5, 7, 9, 11 & 15 Kenaston Gardens and 577 Sheppard Avenue East - Official Plan and Zoning By-law Amendment and Site Plan Applications - Request for Direction Report

Date:	July 24, 2014
To:	North York Community Council
From:	Director, Community Planning, North York District
Wards:	Ward 24 – Willowdale
Reference Number:	13 225019 NNY 24 OZ & 14 145584 NNY 24 SA

Attachment 1: Site Plan

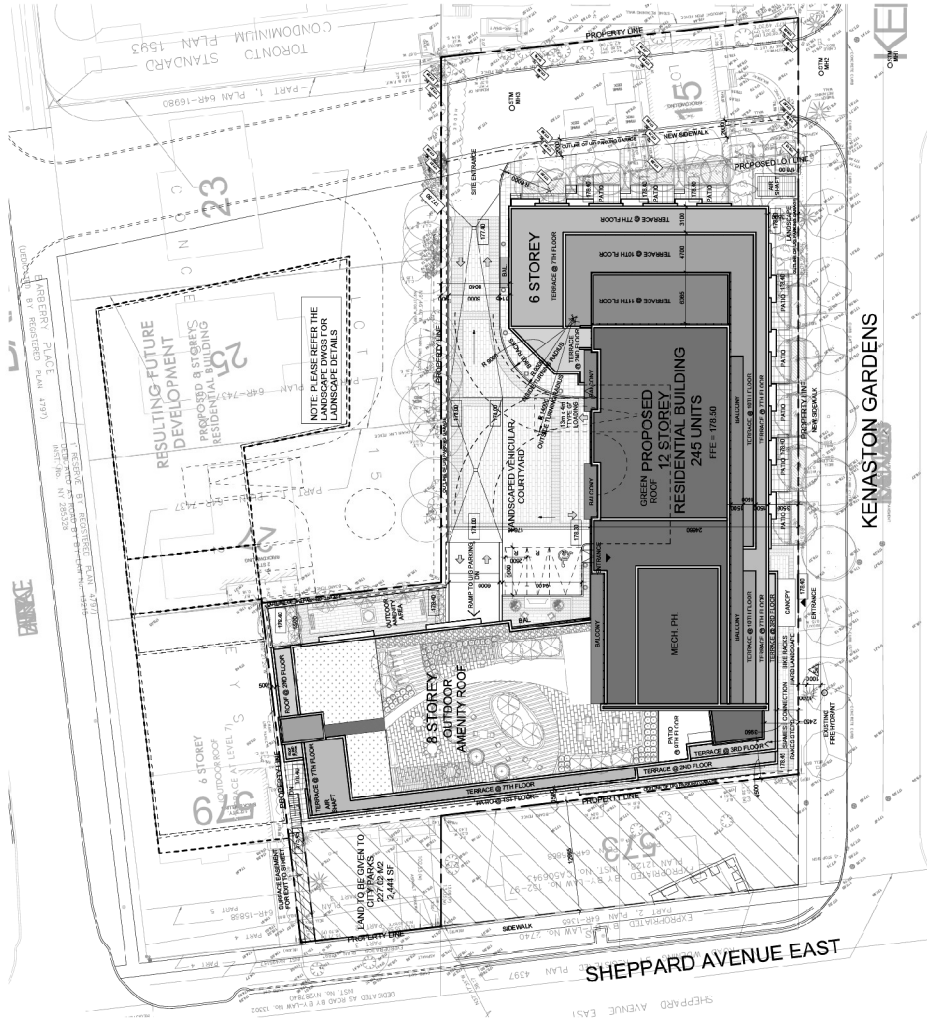
With respect to the subject application, Planning staff would recommend built form modifications on the east side of the proposed development along the Sheppard Avenue East frontage as well as at the southeast corner of the building adjacent to a proposed internal driveway. To ensure the proposed development does not impact or limit the development potential on the remaining lands within the block, Planning staff would recommend these easterly portions of the proposed building be extended to the east property lines to create a zero lot/party wall condition. This would assist in facilitating the maximum permitted density assigned under the Secondary Plan on the remaining lands on Block C.

The Kenaston Gardens frontage is set back 3.5 metres from the property line. The south side of the building, where the project faces the private driveway is setback approximately 7.5 to 9.8 metres from the private driveway. The building is aligned along the street and private driveway edges to provide an appropriate street presence and street enclosure with consistent setbacks to accommodate landscaping opportunities and general site amenity. The ground floor design along these edges includes residential units having street and grade related access. The existing sidewalk along the Kenaston Gardens frontage would be replaced by a new 1.7m wide concrete sidewalk and the public boulevard would be planted with trees.

Planning staff is concerned with the relationship between the ground floor uses, particularly at the east end of the site and the park edge. The site slopes down from Kenaston Gardens towards the east along Sheppard Avenue East approximately 3 metres, or one storey. Owing to the difference in grade, the finished ground floor of the building is elevated approximately 1.75 metres above the existing/future park (at the easternmost point). Rather than step the finished floor, the applicant has elected to address the difference in grade through landscaping. Staff has concerns with this design and the relationship the units have with the park. Staff is recommending building be redesigned to make these units accessible at grade along the edge of the existing/future linear park to ensure these spaces animate the edge of the park.

3. As part of the continued discussions respecting the proposal, the issues set out in this report shall be addressed including:
 - i) The provision for a 20 metre wide public road along the southern portion of the site;

- iii) Extending the built form along Sheppard Avenue East as well as the southerly building wing to the east property lines to create a zero lot line/grade party wall condition;

- v) An improved grade relationship between the finished ground floor elevation of the proposed development and the existing/proposed linear park.
4. In the event that the OMB allows the appeal in whole or in part, City Council direct the City Solicitor to request that the Board withhold any Order to approve an Official Plan Amendment and Zoning By-law Amendments for the subject lands until such time as:

Attachment 4: East Elevation

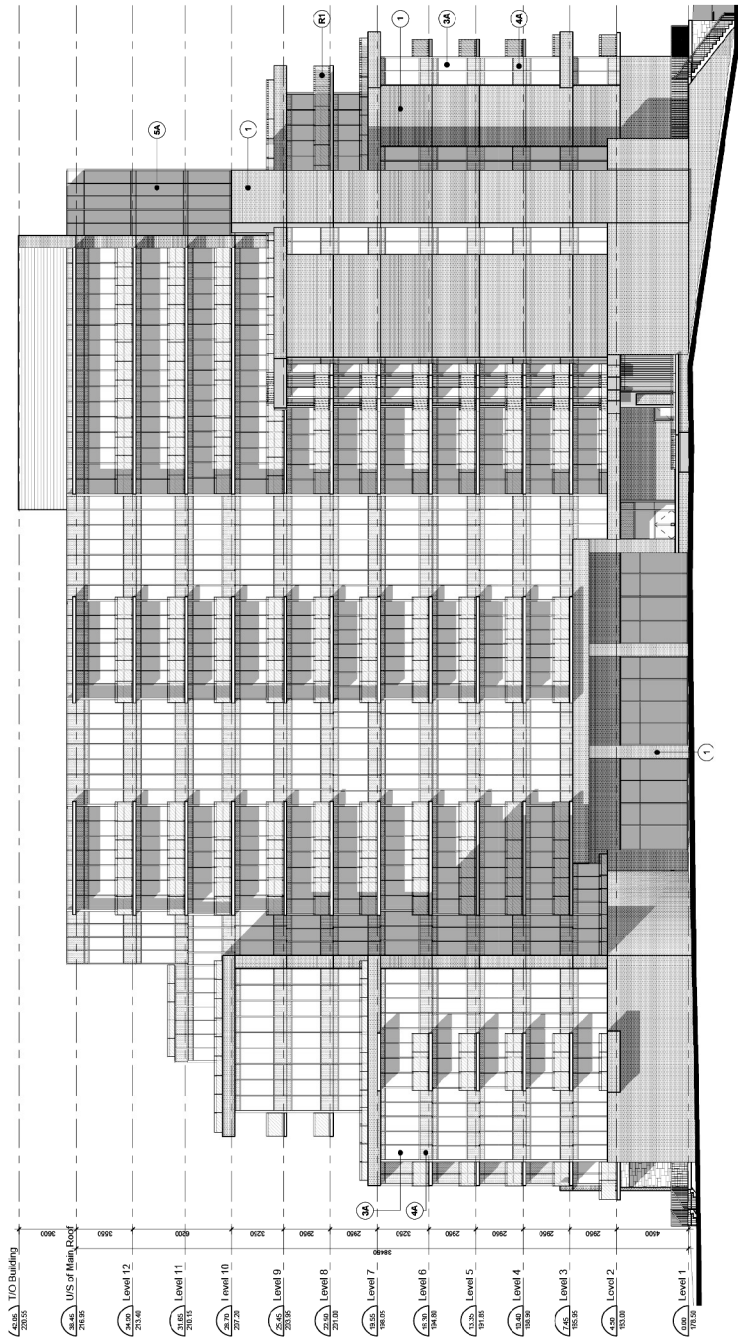
Further, Planning staff would recommend the east elevations include detailed elevation articulation and/or building finishes that complement the architectural character of the main façade so as not create an unattractive blank wall condition. These façade treatments would be secured through the Site Plan process.

- iv) East building elevations designed to include detailed elevation articulation and/or building finishes that complement the architectural character of the main façade and a "Gateway" feature at the northwest corner of the site in keeping with the objectives of the Southeast Bayview Node Context Plan; and

Attachment 8: East-West Sections

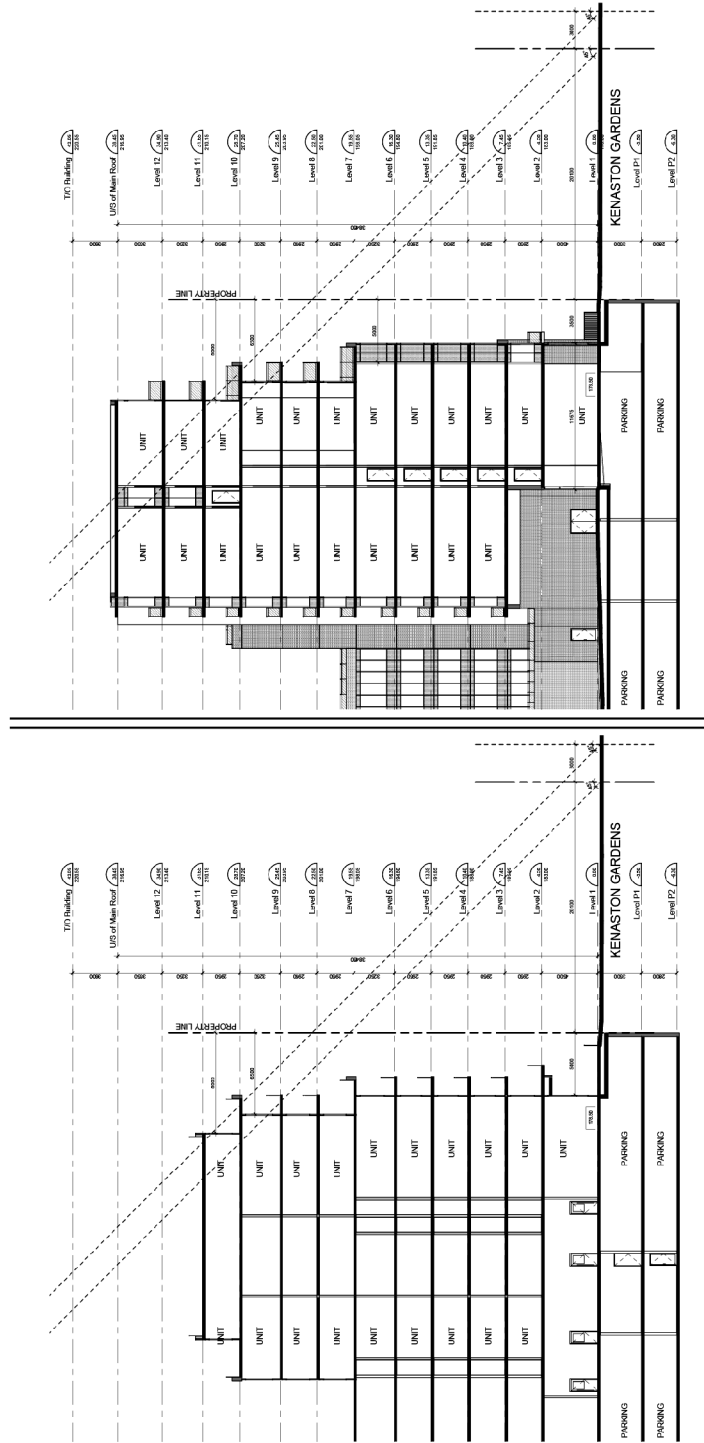
The application proposes a 12-storey height along the Kenaston Gardens frontage of the site that steps down to 6-storeys to the south. As illustrated on Attachment 8 – East-West Section, a portion of the building is outside the angular plane generated by the 1:1 height to street ratio line.

Staff is recommending the height along Kenaston Gardens be reduced from 12 to 9-storeys. In view of the existing built form within the neighbourhood, a building height in the range of 9-storeys along Kenaston Gardens, with an upper floor design that addresses the 1:1 height to street ratio policy in the Secondary Plan would be appropriate. This would need to be reviewed in detail as part of continued discussions and a revised proposal.

- ii) A reduction in the building height along the Kenaston Gardens frontage and relocating some of the floor area to the northwest corner of the site;
